NUCLEAR REGULATORY COMMISSION

DISCUSSION AND POSSIBLE VOTE ON
SEQUOYAH HYDROGEN CONTROL

December 15, 1982

LOCATION OF ADDITIONAL IGNITERS

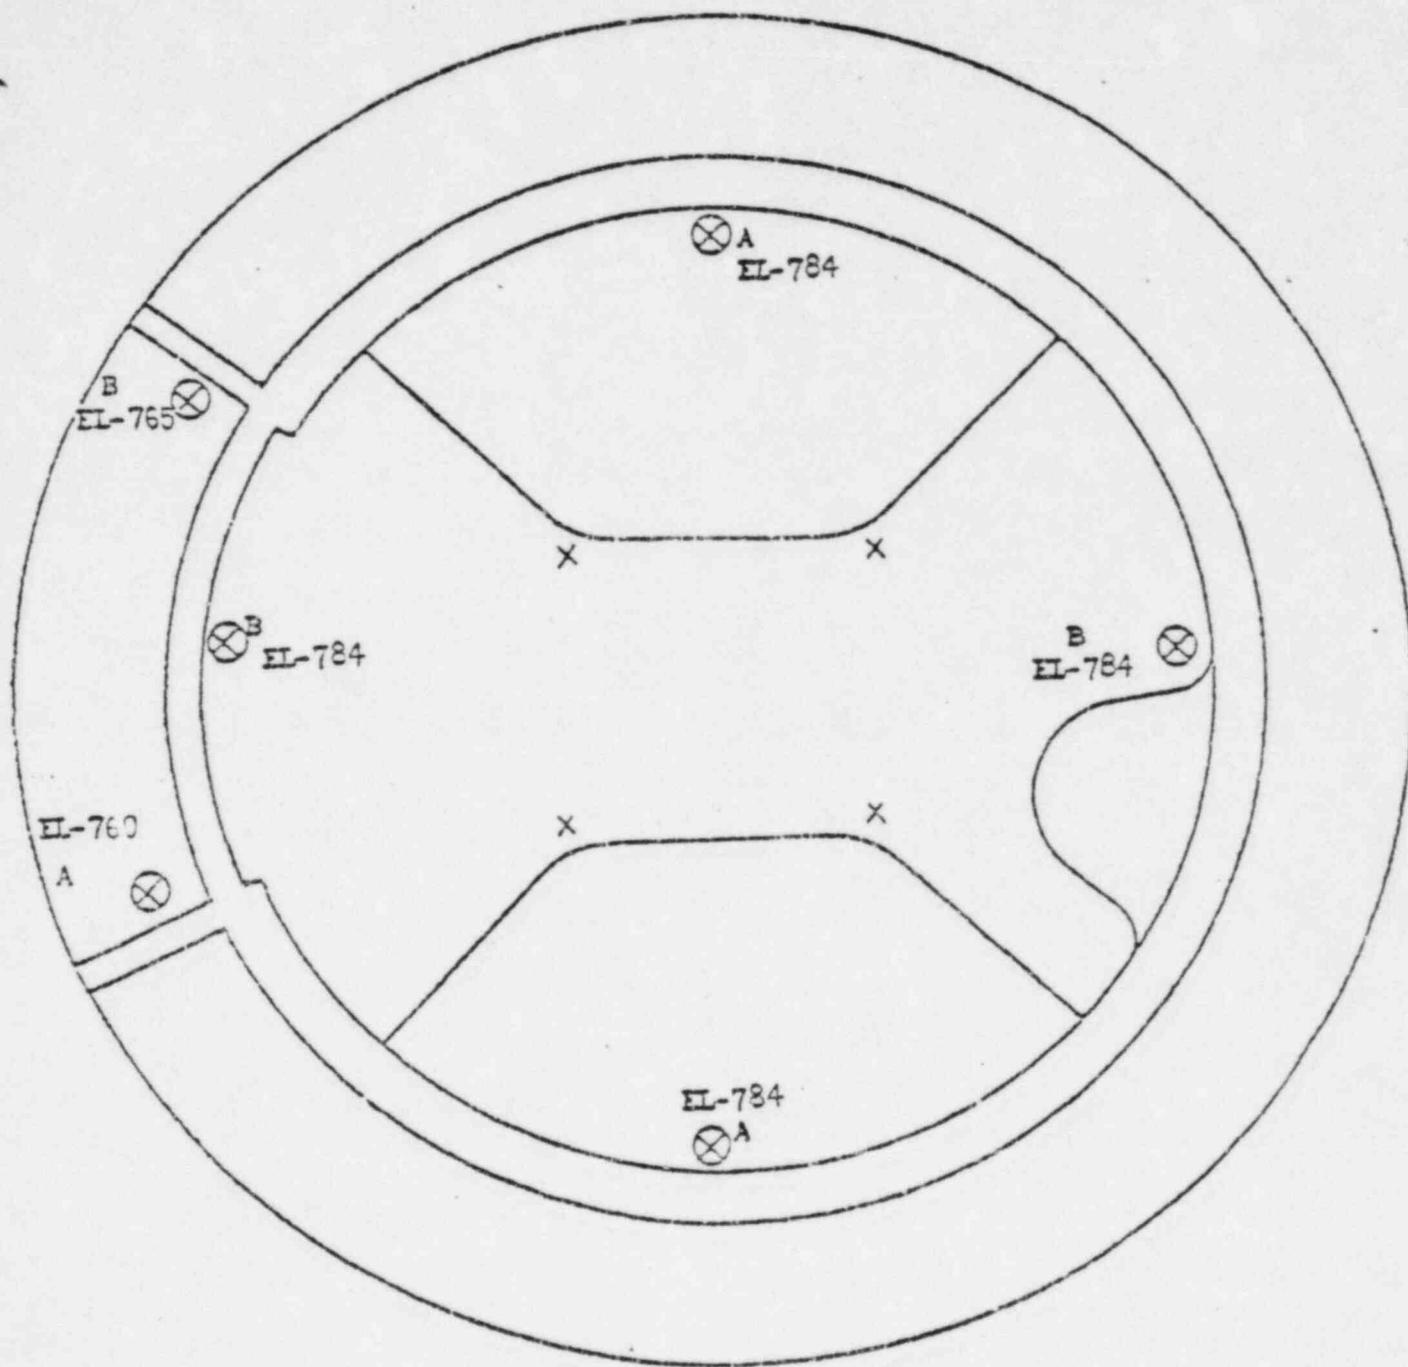
14 COMMISSIONER ROBERTS: Yes, let me ask you a
15 question. I am reading from the SER, this is page 22-5,
16 "Installation of additional igniters in the upper
17 compartment will provide greater margin of safety."
18 What is the incremental margin that this is going to
19 provide?

2 Charlie, do you just want to start with B-6
3 and B-7, can you put them up on the screen, please? B-6
4 first, and point out where the additional ones go, and
5 then show how they provide this staggered coverage?

1 MR. MATTSON: No, no. We think it is adequate
2 for restart, with 64. We put 68 in, given that there
3 are many years left in the operation of this plant and
4 it is not a big expenditure, and it can be done.
